LETTER OF OBJECTION to Planning Application 2023/5338/P submitted 13 Feb 2024

Site Address: Alexandra Road Estate, Rowley Way, London NW8 0SN

'Replacement of the existing estate-wide heating distribution infrastructure including removal of redundant pipework; installation of two new sub-plant rooms; installation of cold-water storage tank rooms; replacement of existing site hoarding and installation of new replacement infrastructure pipework.'

Photo of concrete fins with the new proposed pipework from the report.

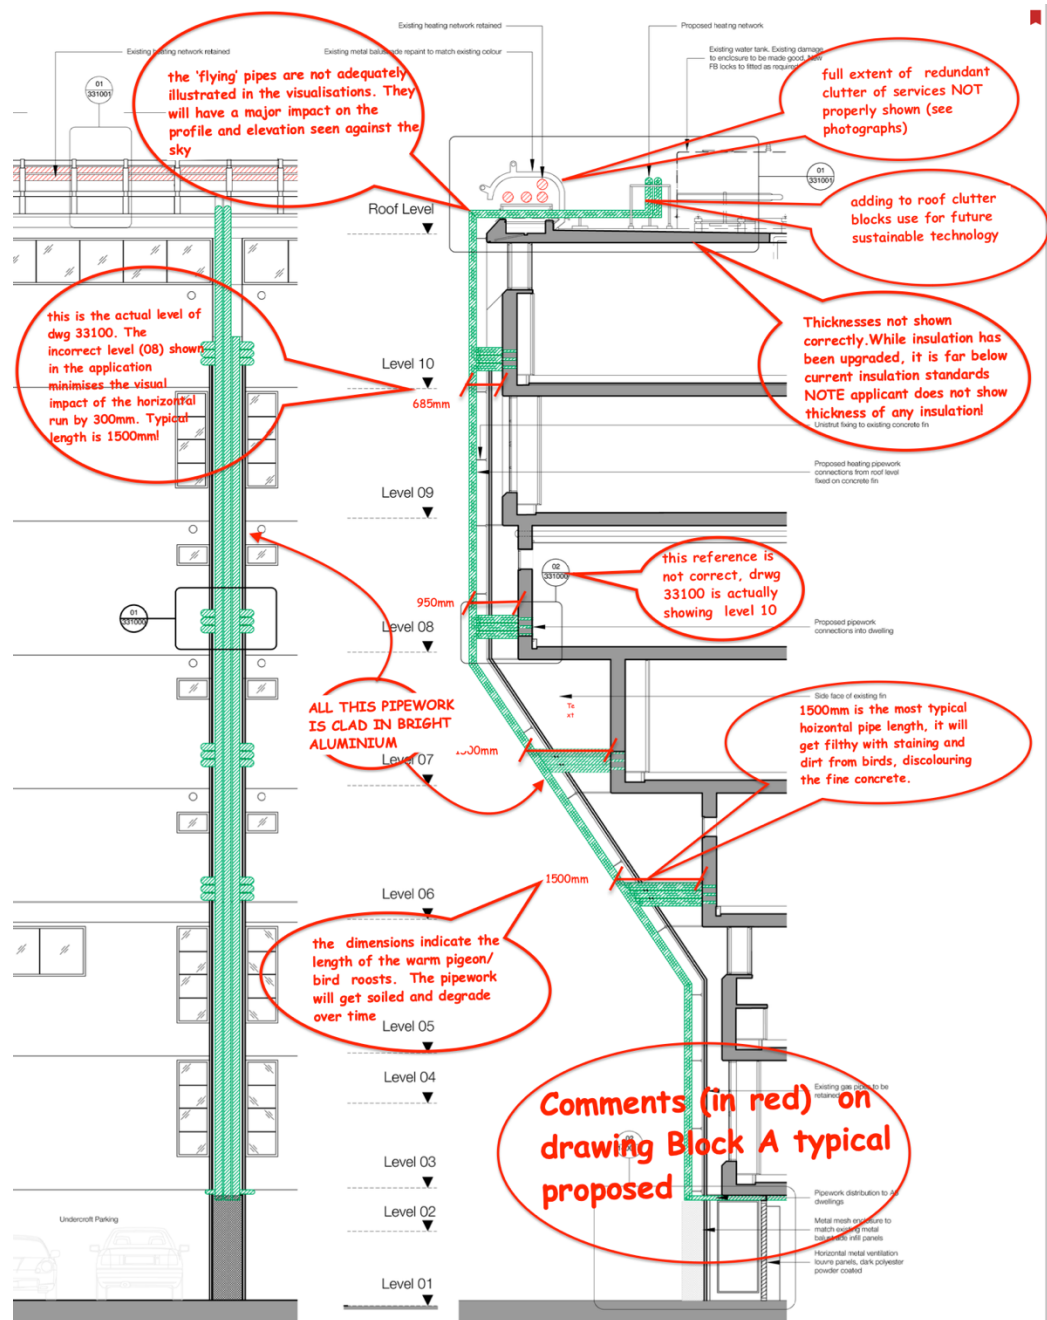
- e) The application proposes that the new distribution pipe work will run vertically up **every other** concrete fin. This pipework will then be covered with bright aluminium casings destroying the homogenous architectural feature and the rhythm of this facade.

This is clearly shown by the technical drawings and CGI illustrations submitted in the application showing the unsightly pipe work somehow bathed in sunlight on a north elevation whereas it is more likely to be covered in pigeon poo.

The illustrations are misleading as they only show a view from the low-level service road. The angle of view also masks the awkward disfiguring set back at the top floor which will have a huge visual impact when seen from the public realm.

The elevation will be radically and irreversibly altered, and heritage destroyed.

f) **Block A- drawing from application of the proposed distribution pipework**

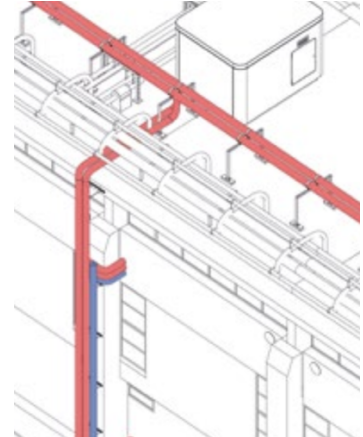
This is marked up with comments to highlight how visually intrusive the pipework will be on the north elevation as the drawings generally do not portray this adequately. For example:

- the number of pipes will make be very unsightly
- the insulation will increase their size and bulk
- the distance the pipes are off the face of the fins will make them perfect pigeon and seagull roosts
- at roof level the 'flying pipes' from every other fin to the roof will be visually very intrusive against the skyline
- all of which are minimised in the report
- aluminium casings to pipes do not look like concrete!

8.3 Proposed Materials - Typical

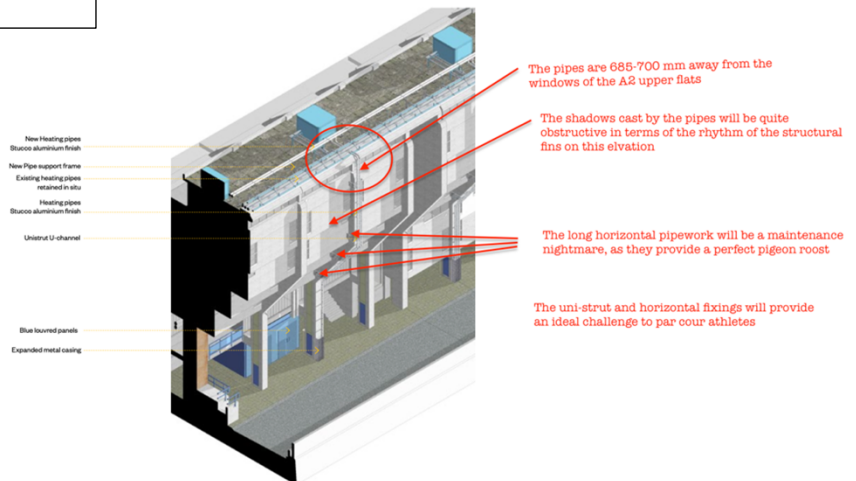
This low resolution drawing starts to illustrate the visual destruction of the iconic elevation facing the railway
